FINAL PLAT OF
"WOODROME ADDITION"
SEDGWICK COUNTY, KANSAS
(SE1/4 OF SEC. 23, T28S, R1W OF THE 6TH P.M.)

RE: S/D 98-78 - Final Plat of WOODROME ADDITION

S/D 98-78 - Preliminary Plat of WOODROME ADDITION

CASE NUMBER: S/D 98-78 - WOODROME ADDITION

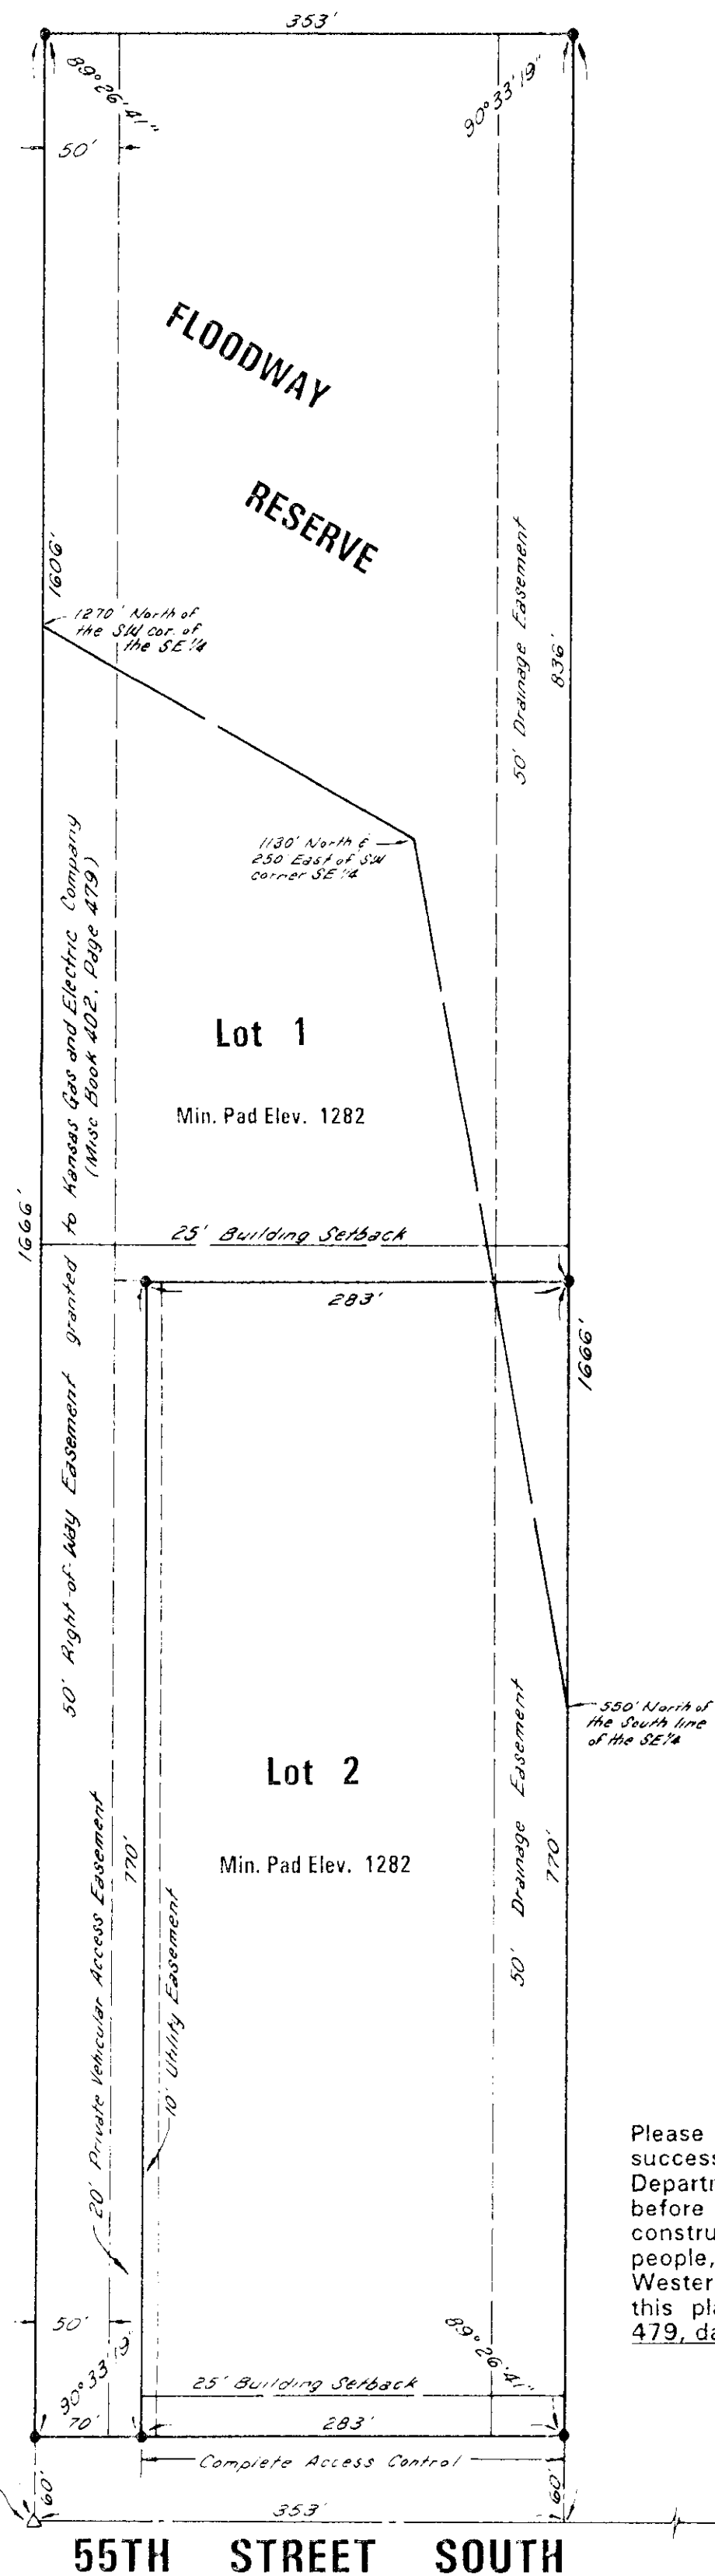
- F. On the final plat, both the face of the plat and the plat's text shall denote access controls along 55th St. South. County Engineering requests 100 feet of

complete access control along the east 100 feet of the lot. One access opening per lot is permitted.

- G. Under SF-20 zoning, a minimum lot width of 100-feet is required, which is measured at the building setback line. Lot 1 shall denote a building setback line located 25 feet from the north line of Lot 2.

- H. County Fire needs to comment on the acceptability of a 770-foot private-type drive for emergency access to Lot 1. County Fire requires that the road be built according to Fire Department access specifications.

- I. Due to the depth of Lot 1 exceeding its width by more than 2½ times, a waiver will need to be granted for the approval of this plat.
- J. The applicant is reminded that a platting binder is required with the final plat. Approval of this plat will be subject to submittal of this binder and any relevant conditions found by such a review.

- R. The representatives from the utility companies should be prepared to comment on the need for any additional utility easements to be platted on this property. **Southwestern Bell requests additional easements which have been denoted on the final plat.**

✓ The applicant has platted completed access control along Lot 2 and an access easement across Lot 1. A cross-lot access easement agreement will need to be established by separate instrument stating which properties are benefited by the easement, which properties are responsible for initial construction and maintenance of the driving surface within the easement, and that obstruction of the easement is prohibited.

✓ The requested setback line has been denoted on the final plat.
